CITY OF LADUE ZONING AND PLANNING STAFF REPORT April 26, 2021

SMALL SUBDIVISION/CONSOLIDATION

Address of property: 10025 and 10029 Conway
Applicant: D&B Realty
Action Requested: Lot Consolidation of 2 parcels into 1

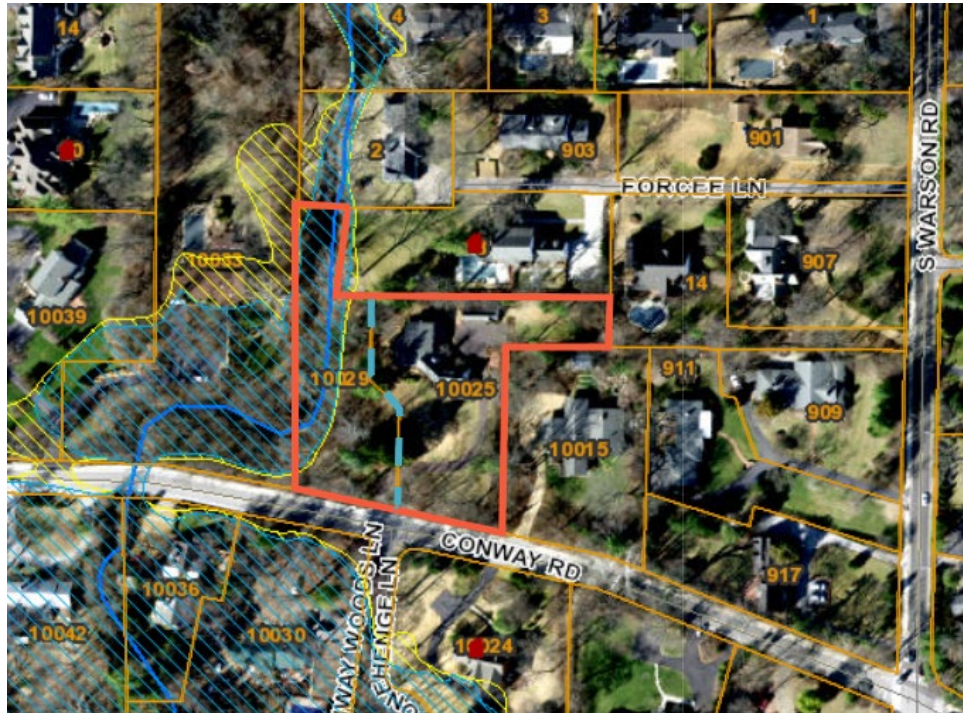
- Property lies in the C Residential District
- The currently existing lots at 10025 and 10029 Conway were created in a subdivision known as H Carter Estates, which was recorded in 1998. Lot 1 of this subdivision is a little over 30,000 square feet and Lot 2 is just over an acre.
- It appears that both lots were transferred to D&B Realty in January and are under the same ownership.
- The C zoning district requires a minimum lot width of 120 feet and a minimum frontage of 90 feet. This subdivision meets these requirements.
- The consolidated subdivision lot will be 1.736 acres in size. This exceeds the minimum required lot size of 30,000 square feet and is in compliance with the zoning code.

- The plat shows the required Ladue setbacks as well as the setbacks from the previous subdivision plat. The City requires that all lots comply with the current setback requirements, even if the setbacks on the subdivision plat are less than our current required setbacks.

- At least half of the existing Lot 1 of the subdivision is in the floodplain, leaving only a small portion of Lot 1 that could be built on.
- The proposed consolidated lot has more than five (5) sides, which is particularly discouraged by the subdivision regulations. The subdivision code states that 5-sided lots may be approved when the lot is more than 30,000 square feet and when the shape of the lot is consistent with other lots in the area. The existing lots are irregular in shape, each having a narrow appendage as part of the lot, and many of the lots near this proposed subdivision are also irregularly shaped. This subdivision is not creating any new property lines; the shape of the lot has been defined by the previous development of the area. The new lot will not have more sides than either of the existing irregular lots.

- This lot is in compliance with the 3:1 maximum ratio of depth to width for subdivision lots.

I recommend that the requirement that the number of sides of the subdivision lot not exceed five (5) be waived. This lot meets the minimum size for such a waiver to be granted. It also meets the other criteria for a waiver to be granted since the existing property lines have been previously established by the previous development of the area and several of the surrounding lots are also irregular in shape.

The consolidation of these lots as depicted on this subdivision plat is recommended for approval.
